Access Compliance Report Public Rights-of-Way (Curb Ramps)

Main Street: STREET_OF_THE_GOLDEN_LANTERN Cross Street: STREET_OF_THE_GOLDEN_LANTERN Location: SW

ADA ID: RPRK220221152635 Ramp Type:Type 1 - Perpendicular Initial Pass/Fail: Pass Overall Compliance: No Severity Score: 16

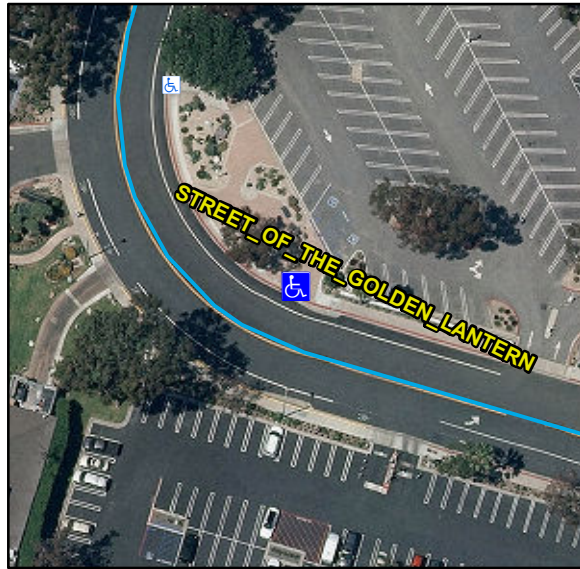
N/A	Ramp Inside Crosswalk 1	N/A	Yes	Ramp Inside Crosswalk 2	N/A
	Crossing 1 Slope (%)	1.1		Crossing 2 Slope (%)	N/A
	Crossing 1 Cross Slope (%)	0.2		Crossing 2 Cross Slope (%)	N/A
Yes	Gutter Ponding	No	Yes	Curb Slope	1.6
Yes	Gutter Lip Height (in)	0		Road Run Slope (%)	N/A
No	Gutter Run Slope (%)	7.7		Road Cross Slope (%)	N/A
Yes	Gutter Cross Slope (%)	0.3			
Yes	Overall Surface Condition: Acceptable		Yes	Perp Joint Present	Yes
	Cross Gutter Present?	No		Spandrel Present?	No
	Replace Cross Gutter?	N/A		Replace Spandrel?	N/A

Remove & Replace Entire Ramp. Remove & Replace Gutter.
